**TECHNICAL REPORT**  
**TR-NAVFAC-EXWC-EX-1401**  
**SEPTEMBER 2013**

**A BRIEF ENGINEERING ANALYSIS OF THE  
PROTOTYPE NEMSCOM MULTIPLE OUTLET  
MANIFOLD INTENDED FOR USE WITH THE  
SIXCON FUEL TANK ASSEMBLY (NSN 5430-01-  
240-4578)**

James H. Estes

**Figure 2-3. Outlet Configuration #1 with Manifold Installed**

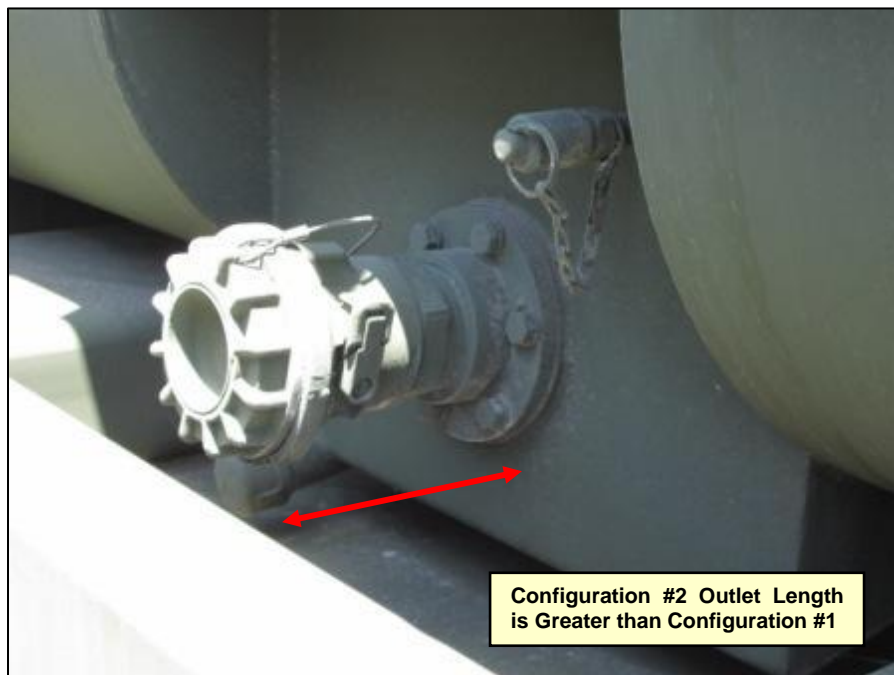
As configured, the three upper outlet valves are positioned well above the lowermost portion of the existing SIXCON tank outlet (see figure 2-3). This configuration reduces the amount of usable fuel that can be gravity-fed to the receiving ground units as compared to that available through the five lower outlet valves. Ideally, the manifold should be configured to provide access at any of the multiple outlet valves to all of the fuel available at the standard SIXCON outlet (i.e. all usable fuel in the SIXCON) rather than limit fuel accessibility at some positions.

**Figure 2-4. Outlet Configuration #2.  
Manifold Can Not Be Installed on This Outlet Configuration**

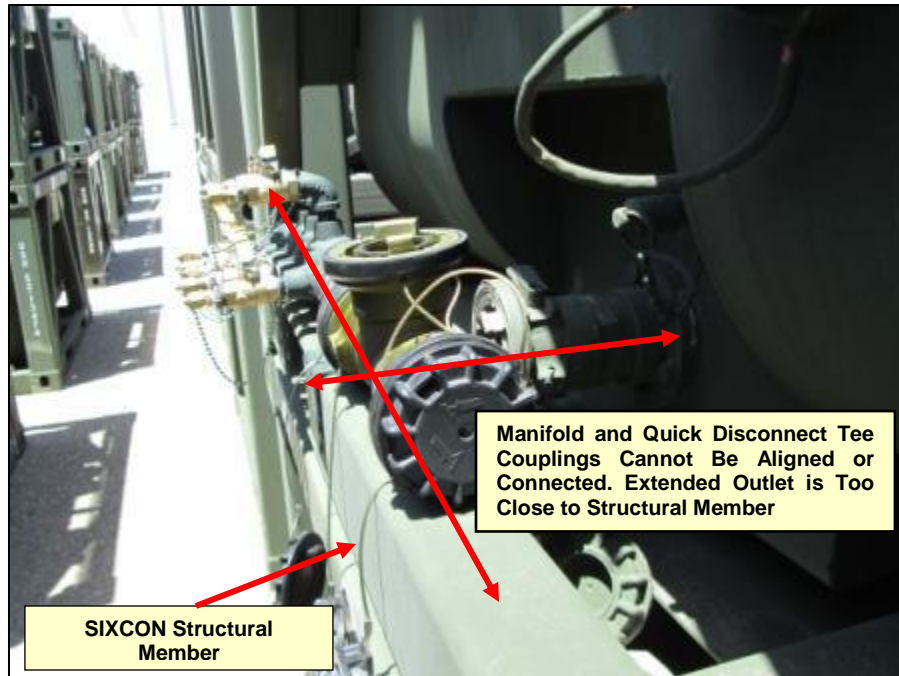
There were three different outlet configurations encountered on the SIXCON fuel tanks even though they all carried the same NSN number, NSN-5430-01-240-4578. The manifold, which is designed to sit on the bottom frame of the SIXCON module while straddling one of the forklift pockets, was incompatible with two of the three configurations. (See Figures 2-1 through 2-7.) Even if the end users were provided hardware and tools to modify the SIXCON outlet configurations #2 and #3 to fit the manifold, the outlets are below the liquid level of the tank and not subject to field alteration with fuel in the tank.

**Figure 2-8. Inconsistent Contents Markings**

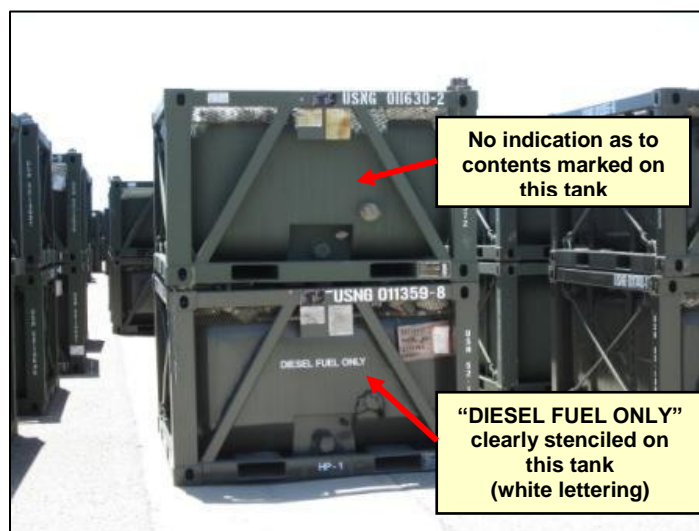
All SIXCONS observed at NBVC had “USMC” stamped on their data tags. (The USMC has a single fuel forward policy and uses JP-8 only.) Some units were stenciled “Diesel Fuel Only”, some stenciled “FUEL ONLY” and others with no markings as to the contents (see figures 2-8 and 2-9). None of the SIXCONS observed were stenciled “JP-8 Only”. It is reasonable to expect that due to the exigencies of warfare and prevailing conditions in service, the manifolds and all components could see service with any of the common fuels used in theater by the Navy/Marine Corps.

**Figure 2-10. Outlet Valves**

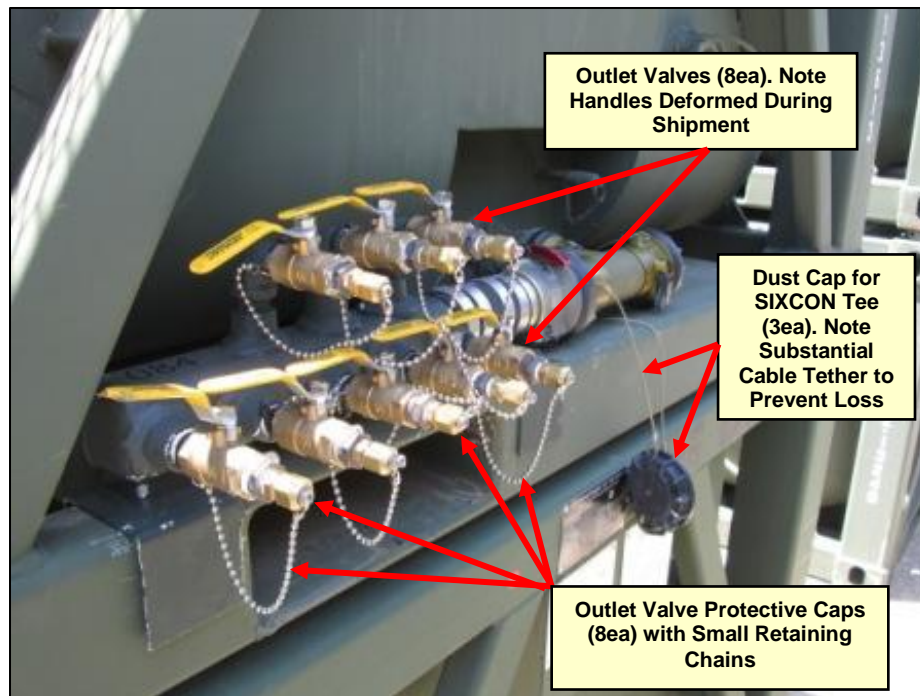
In the absence of any literature, it is unknown for which fluids and pressures the valves are rated. In the absence of engineering data or design criterion, it is unknown as to what pressures the manifold is designed to operate or what safety factors have been observed during design. Outlet valve suitability for use cannot be determined (see figure 2-10).

The handles on the outlet valves are not sufficiently robust for service in the tactical environment. The handles on the unused sample units provided were received bent and misshaped just by the rigors of non-tactical, commercial transport alone. Transport and use in the tactical environment will be significantly more challenging than standard CONUS commercial shipping. Repeated bending and straightening will lead to handle failures, which would in turn render the individual valve unusable.

It is understood that the NEMSCOM prototype manifold was fabricated with flared fittings on the outlet valves to expediently interface with a readily available fuel hose, NSN 4720-00-021-3320. This configuration does not seal either the valve or hose when disconnected. To reduce the possibility of a fuel spill if frequent connections/disconnections are anticipated (no information on the frequency of connections/disconnections was provided) the flared outlet ports on the outlet valves as well as the connecting ends of the hoses, should be fitted with suitable dry-break couplings..

The small retaining chains on the outlet valve protective caps and their attachment means (plastic wire-ties) are not sufficiently robust for the tactical environment and will likely fail in service. Loss of the outlet valve protective caps will ultimately lead to damage to the threads and flared ends of the outlet valve fittings, rendering them unusable. All outlet valve protective caps should have retaining cables or tethers of similar size and strength to those utilized on the large dry-break manifold inlet valve dust cap, the SIXCON outlet valve dust cap, and the SIXCON quick disconnect tee dust caps to prevent loss.

**Figure 2-11. Bleed Ports with Removable Bleed Port Caps**

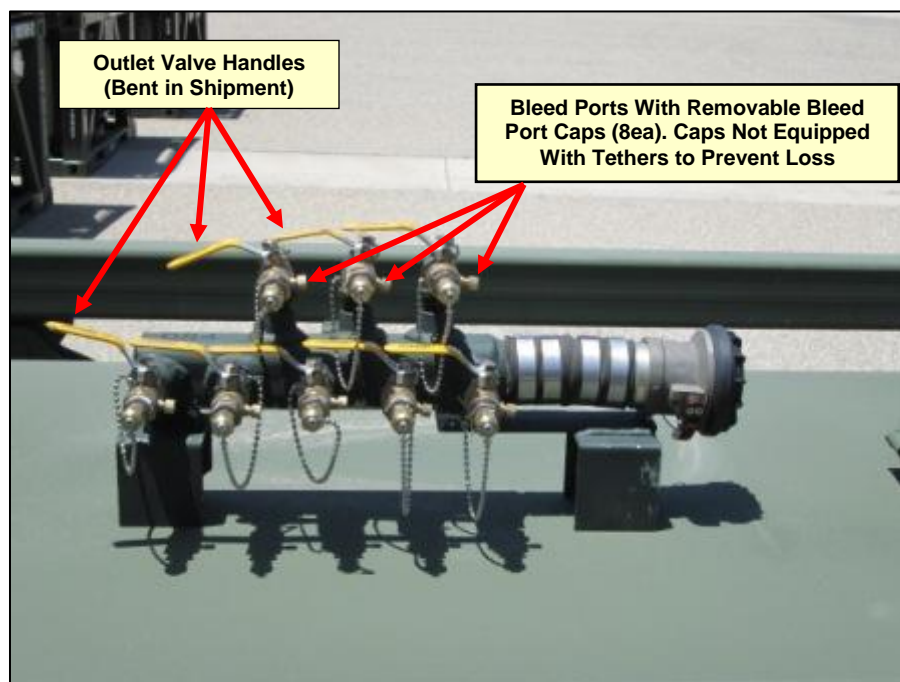
The outlet valves have small caps on the side, which cover what are apparently air bleed, sensor access (pressure, temperature, etc.) or perhaps sampling ports (“bleed ports”) (see figure 2-11). The author is unaware of a useful purpose for the bleed ports in this application and concerned about them providing a potential leakage path. A leakage path could either introduce air into the outlet lines (which would typically be connected to the suction side of a ground unit fuel pump) or result in a fuel spill with the associated hazards. If there is indeed no requirement for the bleed ports and accompanying caps, it is recommended they be eliminated.

The small bleed port caps have gaskets inside made of unknown material. If bleed ports and caps must be included on the unit for function as determined by the end user, it should be insured that the bleed port cap seals (as well as the outlet valves themselves) are made of materials compatible with any fuel to which they could possibly be exposed in the field. This should include as a minimum DL-2, JP-5 and JP-8.

The bleed port caps do not have any form of retaining means to prevent loss. If the bleed port cap from any valve is lost, that valve then becomes unusable. All bleed port caps (again, if bleed ports and caps are necessary for function as determined by the end user) should have retaining cables or tethers of similar size, strength and attachment means to those on the large dry-break manifold inlet valve dust cap, the SIXCON outlet valve dust cap, and SIXCON quick disconnect tee dust caps to prevent loss.
